**ARLINGTON AVE.
 WIDENING
 AT PHOENIX**

* "AS BUILT" 4-23-75 J.P.G.

ACCOUNT No. 30-573-265-09
 DRAWING NUMBER
R-1729
 SHEET 1 OF 5

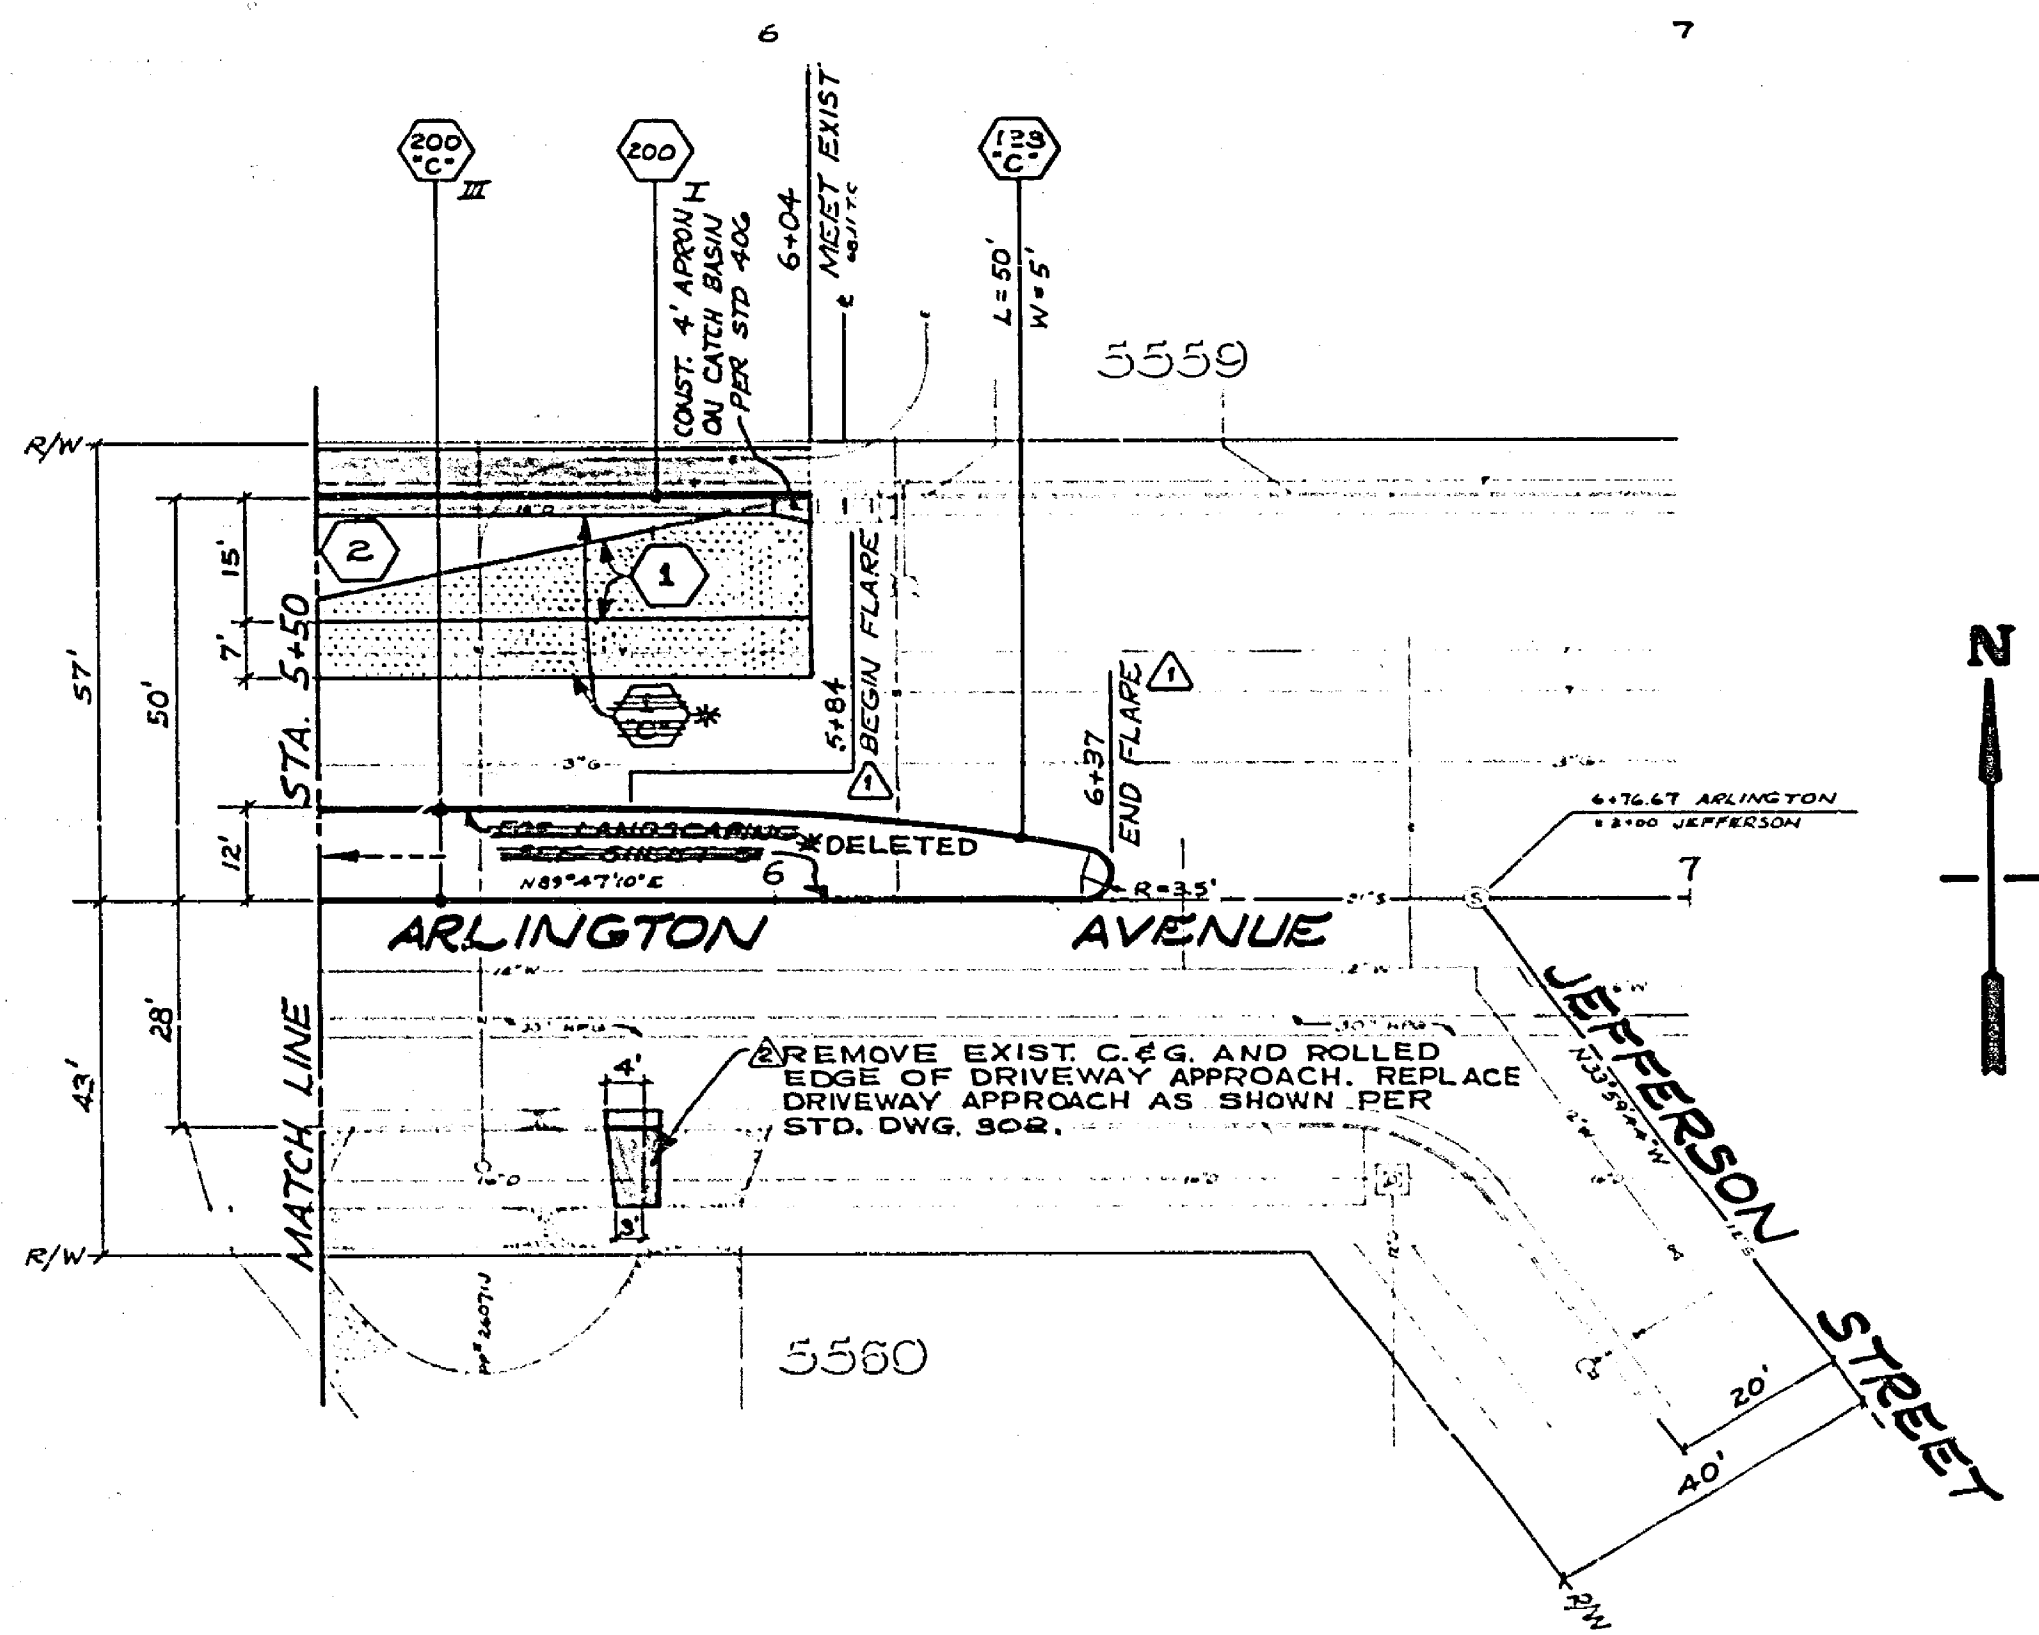
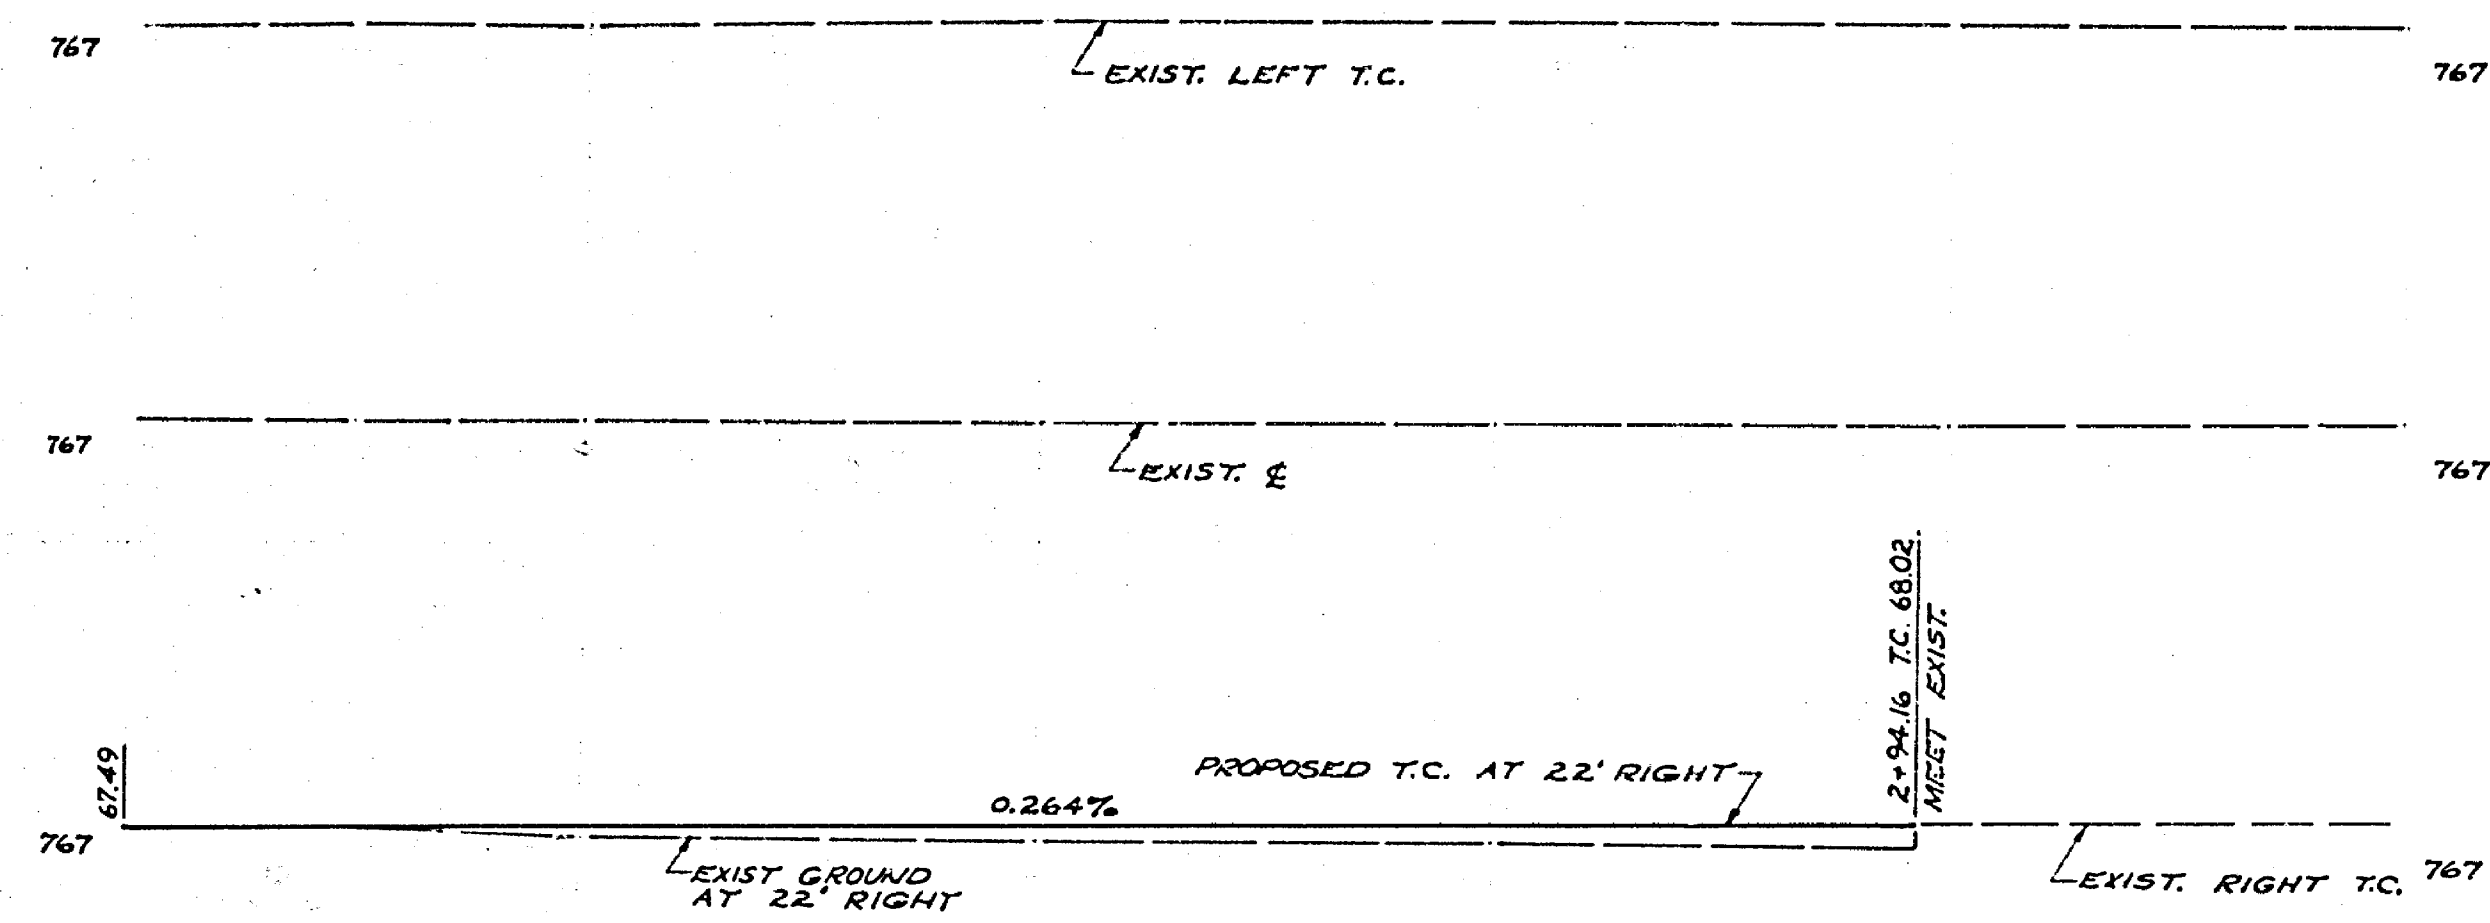
△ MOVED END OF MEDIAN FROM 6+50 TO 6+37 △ WIDEN DRIVEWAY APPROACH PER C.O. N21	CITY OF RIVERSIDE PUBLIC WORKS DEPARTMENT	Arlington Avenue Widening at Phoenix	ACCOUNT NO. 30-575-263-09 R-1729 SHEET 3 OF 5 FILE NO.
DESIGNED BY: D.L. DRASH/STP CHECKED BY: J.C. FERRIS/STP	APPROVED BY: William S. Anderson PUBLIC WORKS DIRECTOR	DATE: 7/25/74	HORIZ. SCALE: 1" = 20' VERT. SCALE: 1" = 4'

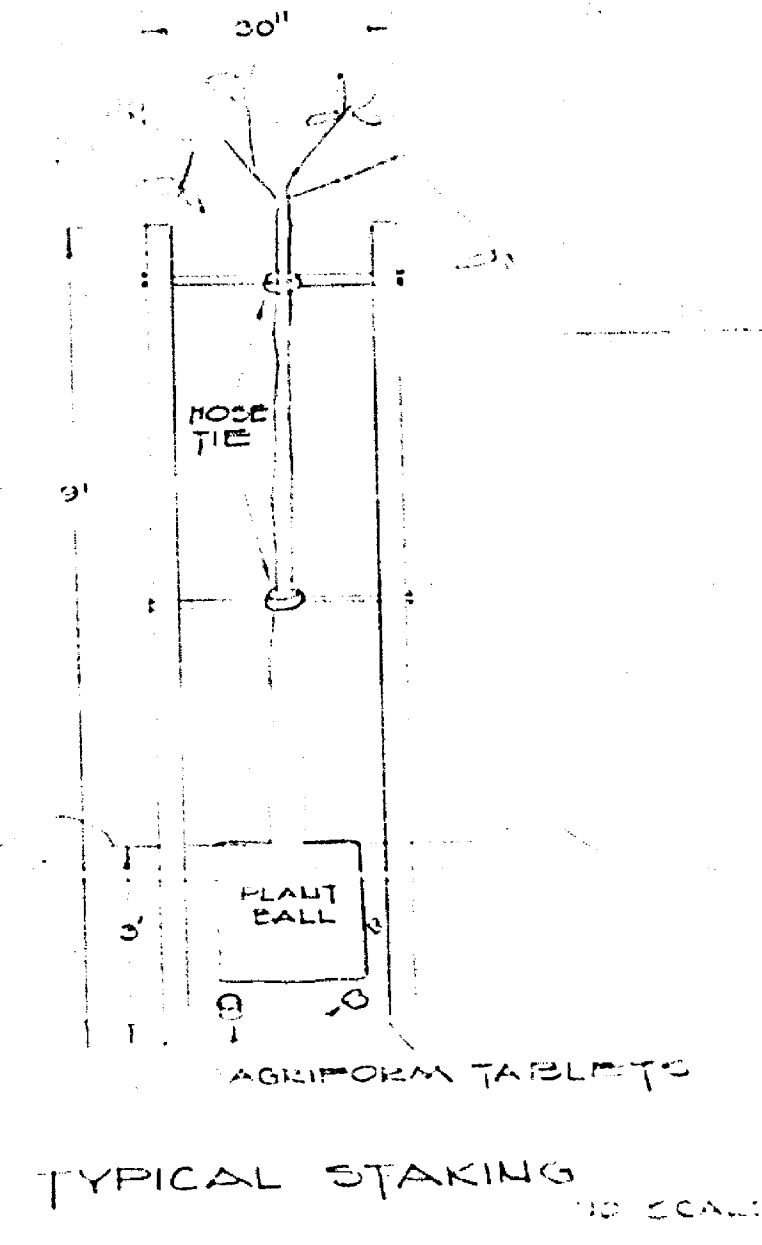
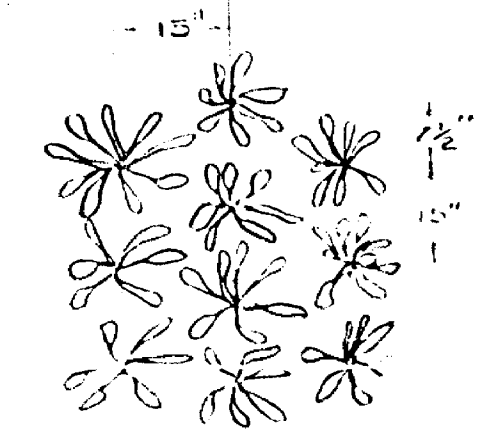
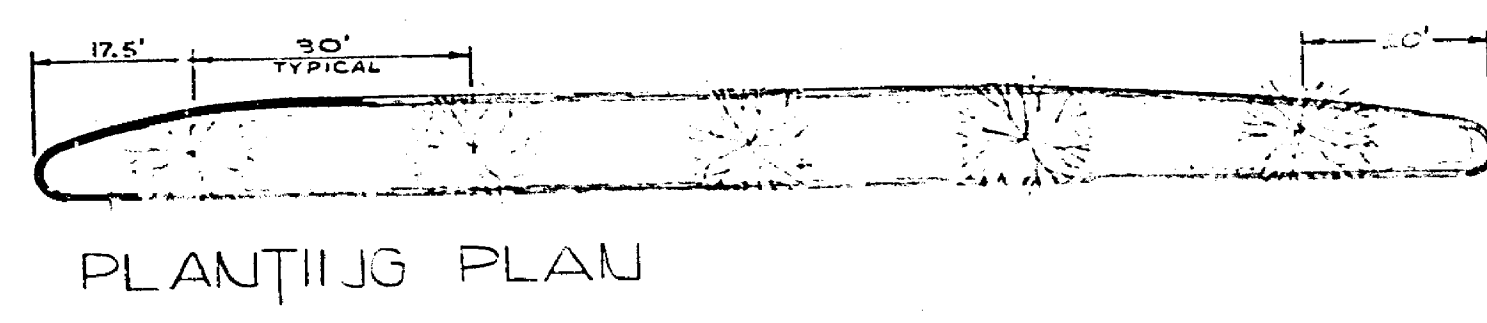
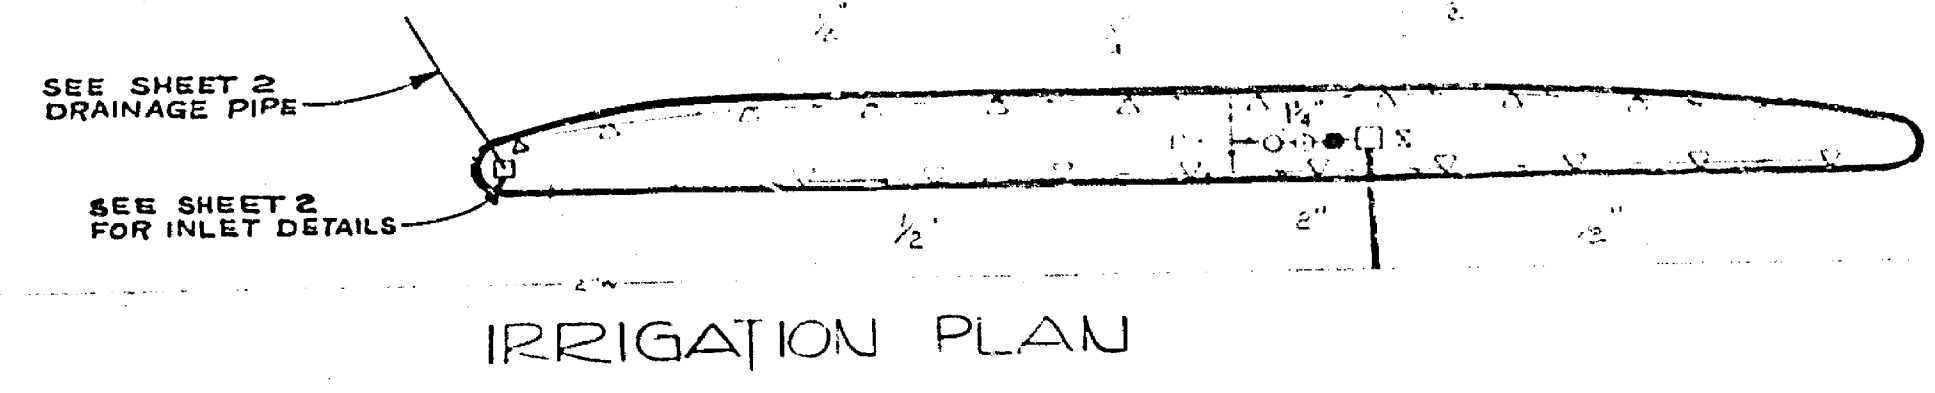
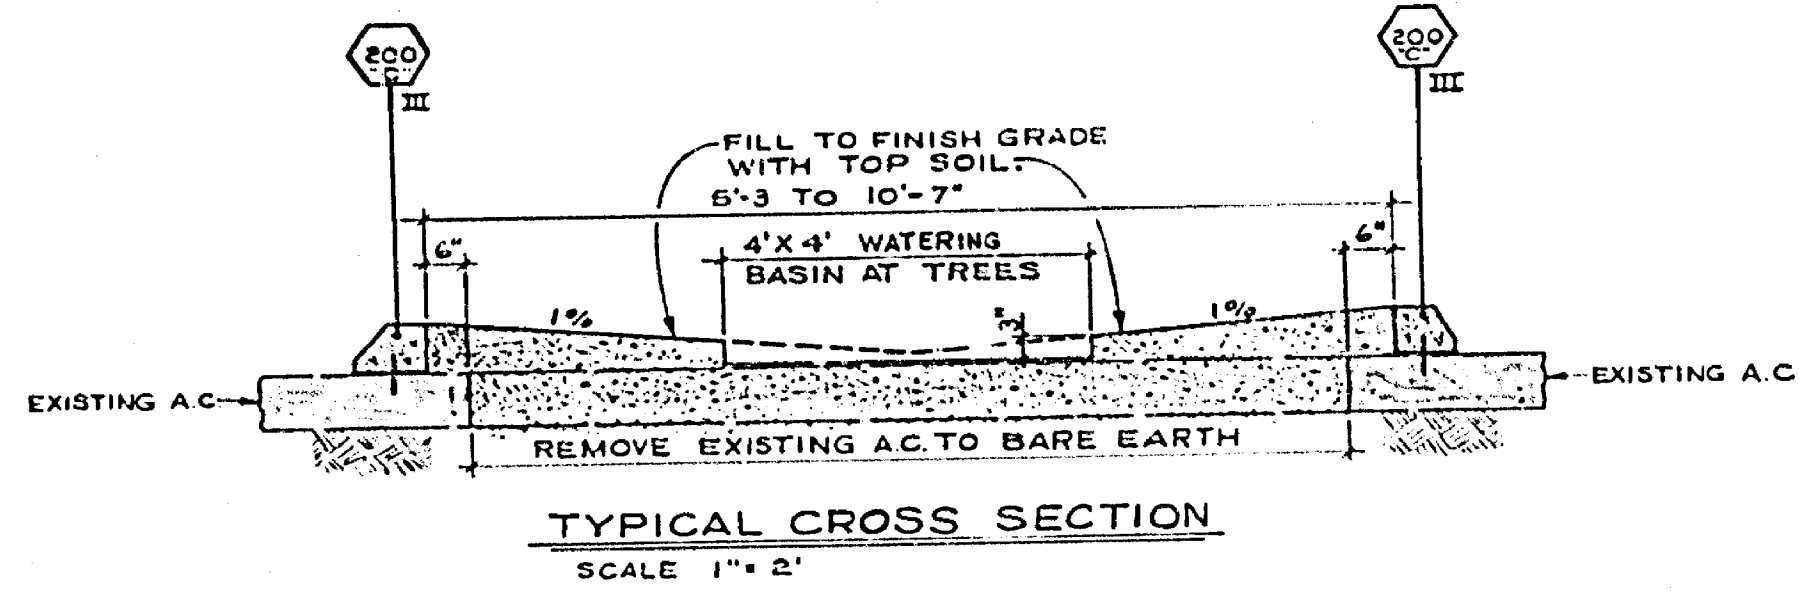
*LANDSCAPING OF MEDIAN WAS DELETED FROM THIS CONTRACT.
